UNITED STATES ENVIRONMENTAL PROTECTION AGENCY

**Re: EPA Decision: Duwamish Sediment Other Area
Southern Boundary Sampling and Western Boundary Dispute
Boeing Plant 2 Seattle/Tukwila, Washington
EPA ID No. WAD 00925 6819
RCRA Docket No. 1092-01-22-3008(h)**

**Additional Sampling and Analysis, Southern Boundary
Data Quality Objectives Memorandum, Revision 1**

Figure 1. Area of Interest for this Memorandum

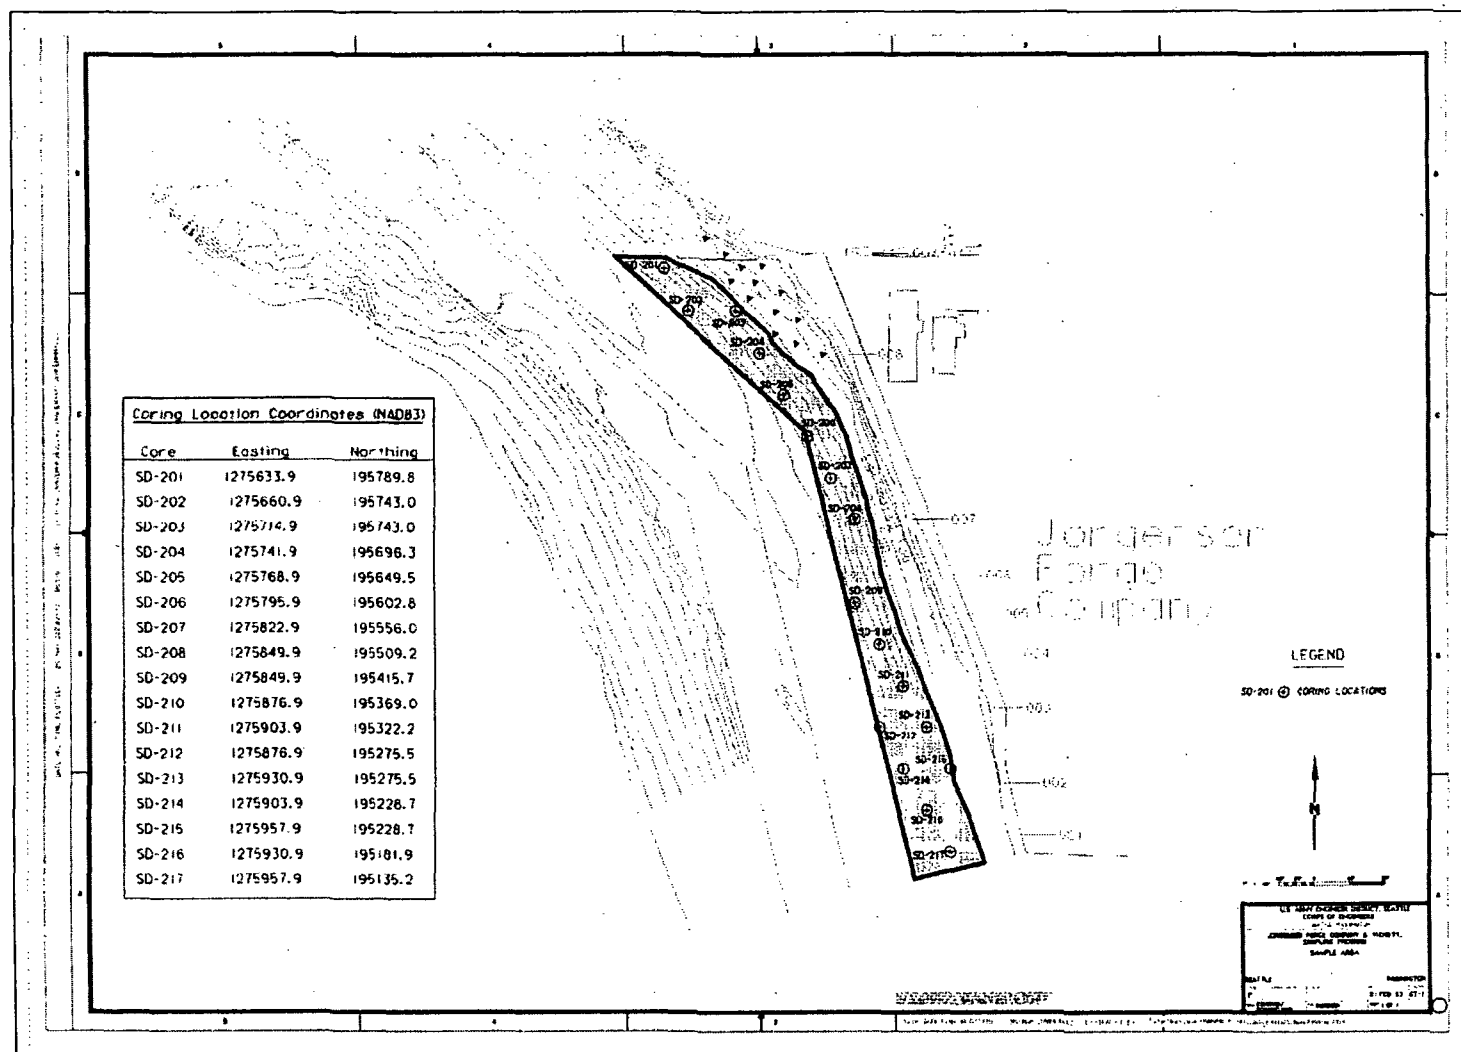
The target area for this investigation, and relation to other adjacent areas. Figure 1 shows the extents of the area to be sampled under this memorandum. This area is referred to as area I in this memorandum. Area I is bounded on the north by the DSOA/western margin of DSOA; on the west by the Federal navigation channel, on the east by a line 50 feet off the toe of the riprap slope (except for a short distance between outfalls 007 and 008, where it is reduced to about 35 feet off of the riprap toe); and on the south by the southern property line of Jorgensen Forge. The figure shows the array of "Phase I" core locations (triangular symbols) from Boeing (2003). The target area includes the prospective Phase II area, as described in the "Transformer PCB Release Investigation Work Plan, (WESTON 2003), which was not defined in this investigation. Finally, the primary collection program is restricted to PCB, metals, grain size and Total Organic Carbon.

Vertical sample acquisition shall occur at locations shown in Figure 1, and described further below. Cores shall be segmented at 4 depth intervals (0-0.3, 1-2, 2-4, 4-6 feet BSS). At a minimum, analysis of the top two intervals shall occur for all cores. If the 1-2 foot interval is above SQS, the cores at depth 2-4 and/or 4-6 BSS must also be analyzed. The surface and 1-2 ft samples shall be submitted for grain size analysis. All core segments will be archived at 4| C in the dark awaiting a determination of whether to analyze or to reanalyze.

The sampling array was developed using Visual Sample Plan (DOE, 2002), based upon a 99% confidence of discovering a 35-ft major axis elliptical hotspot at a 30' to the main river axis. (The former terminology of "gradient," "confirmation" and "spatial data gap" samples has been dropped.) This gridwise approach, which is in line with EPA (2002b) guidance for statistical sampling, is similar to that proposed by Boeing in area D. The chief difference between the latter investigations and this one is that, because active sources are expected to be more remote in area I, a larger potentially "missed" hotspot size was deemed to be appropriate, because it is expected that contamination will be more homogeneously spread and therefore easier to detect. The approach results in 17 samples being identified. The appendix is the report from Visual Sampling Plan, and Figure 1 shows the locations placed onto the Boeing-provided base map with the limits of Area I indicated.
